PRELIMINARY FINDINGS AND DETERMINATIONS Type II Zoning Permit Foothills Solar Park and Substation Special Review #915

TITLE: Foothills Solar Park and Substation, Special Review #915

APPLICATION TYPE: Special Review #915

PRELIMINARY PLANS
NOT FOR CONSTRUCTIONSHEET NUMBER
L100
OF 6 SHEETSJOB NUMBER
U15009

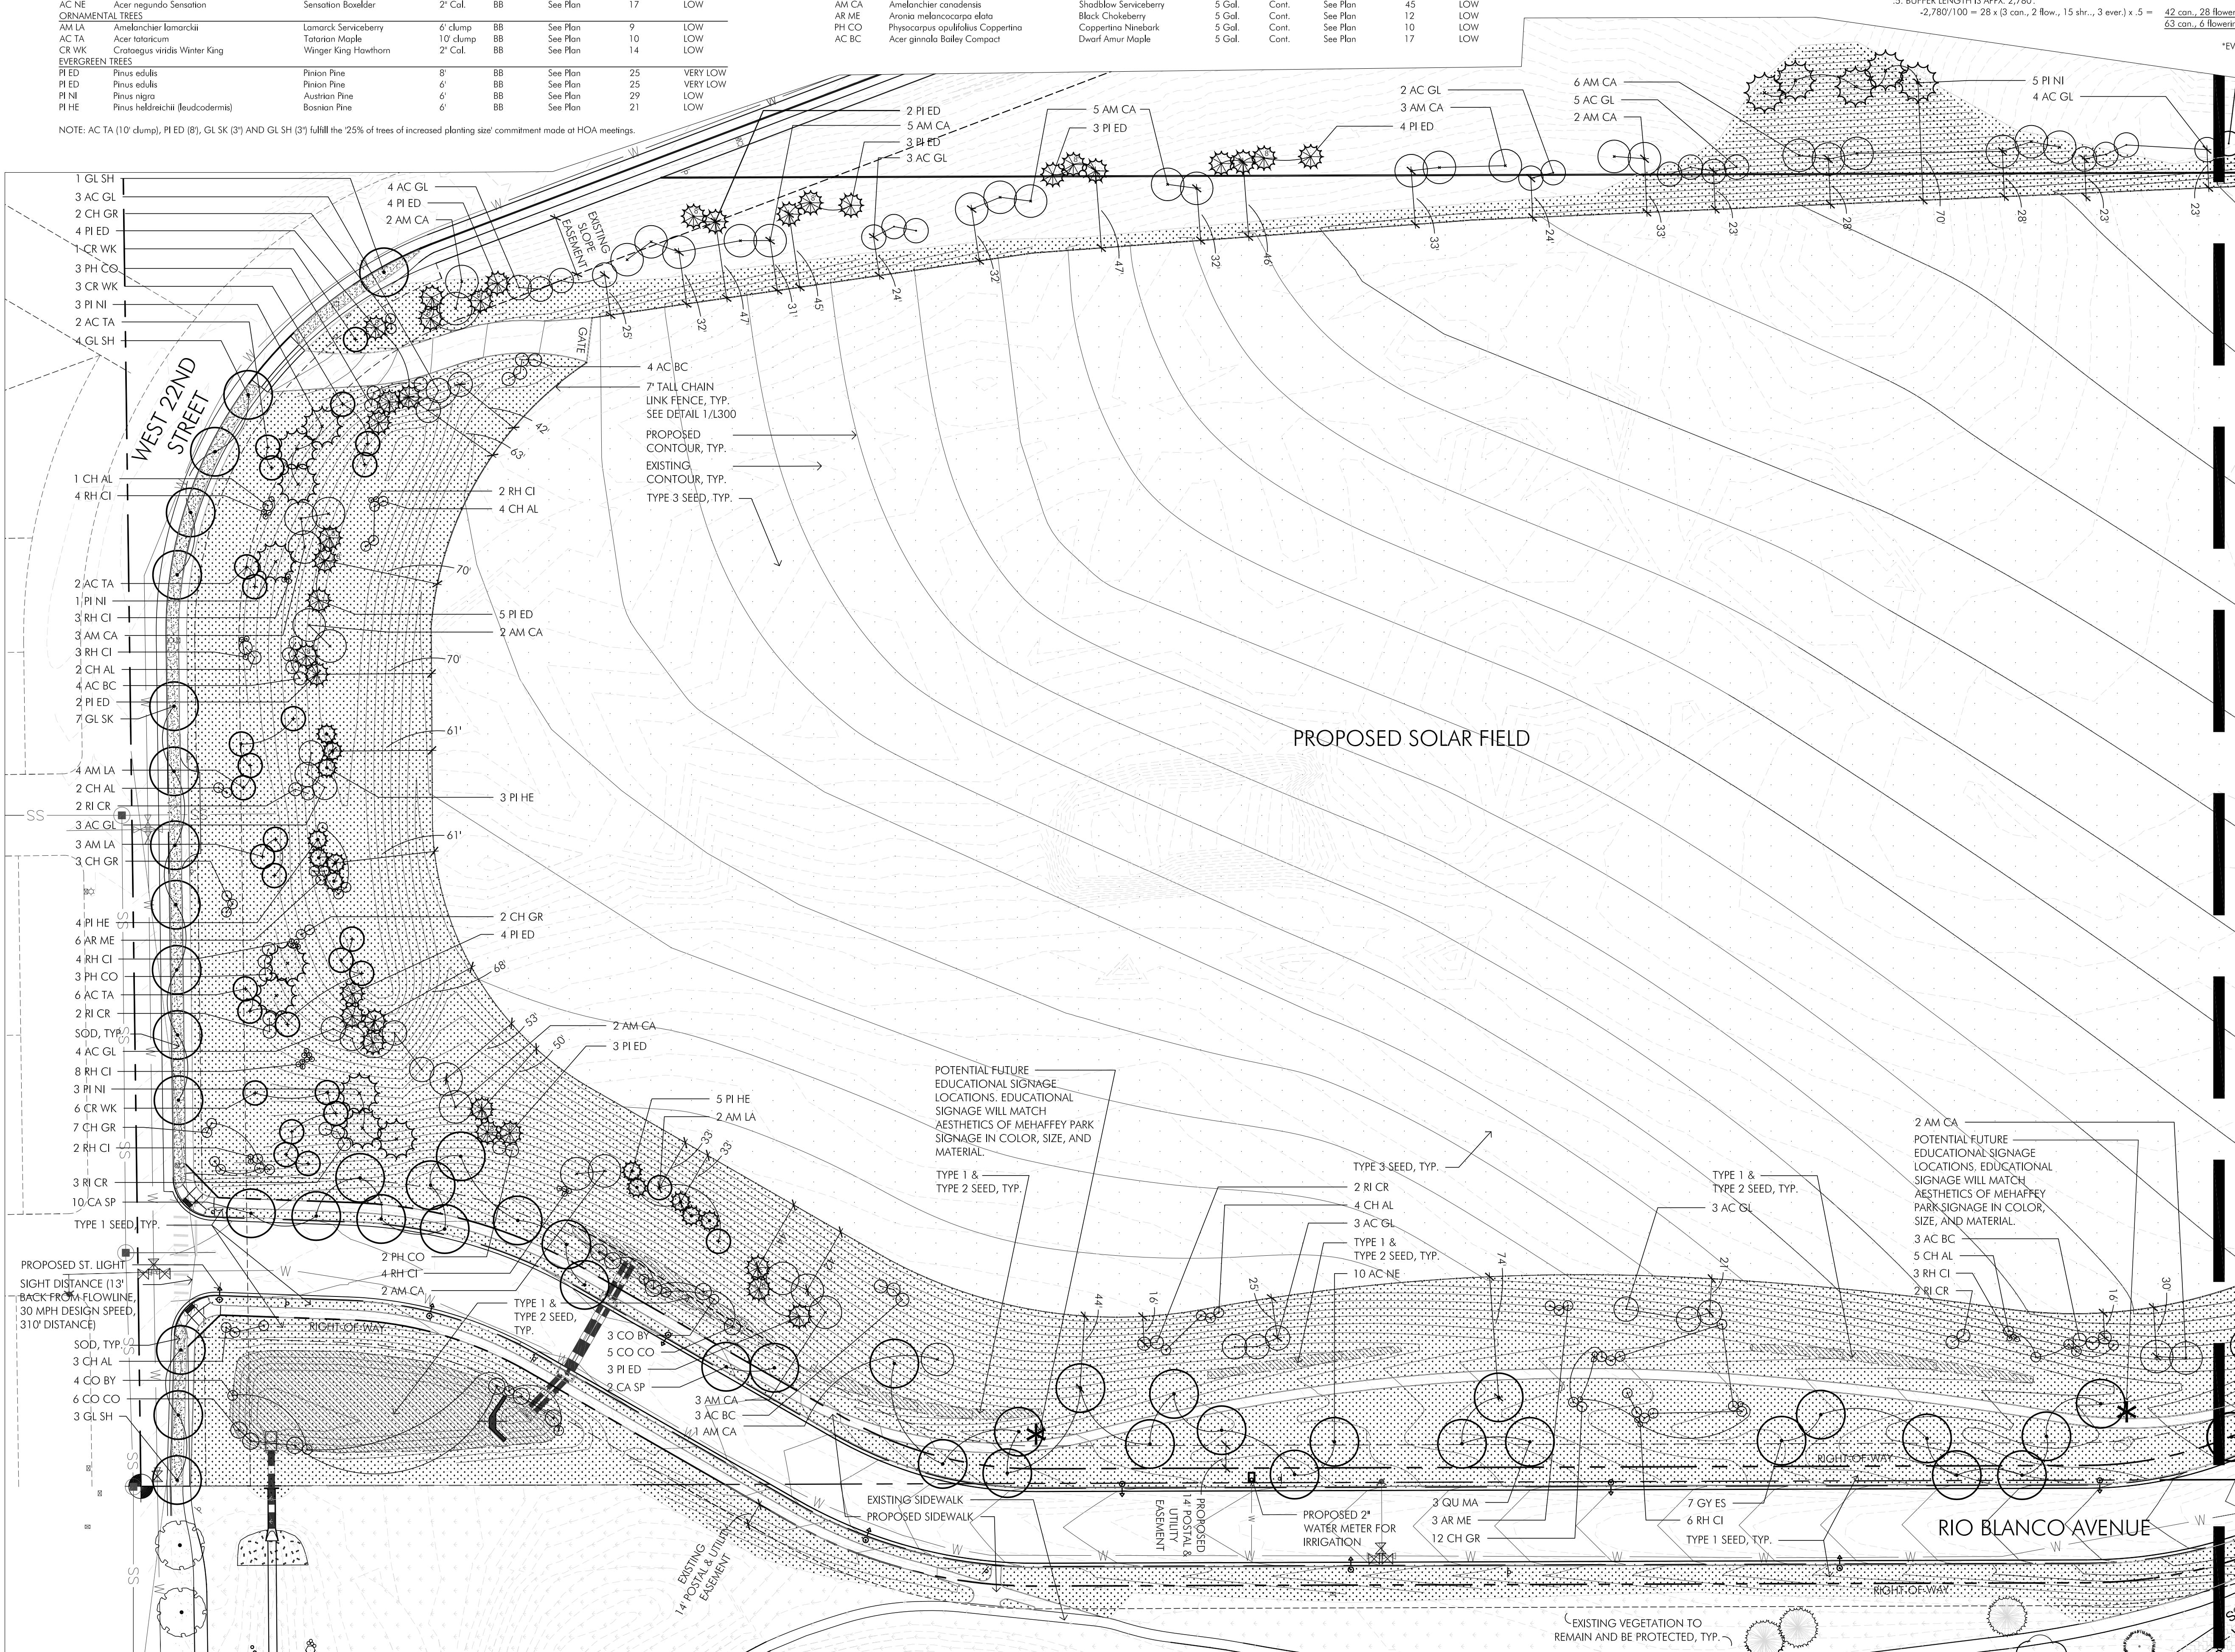
1. Sheet C200-The crossing is missing the insulation design as previously requested.
2. Landscape plan -- do not add trees (PI HE) directly east of the east side of the pump station building.
3. Landscape plan -- please add the Total Irrigated Area amount on the Landscape plan.
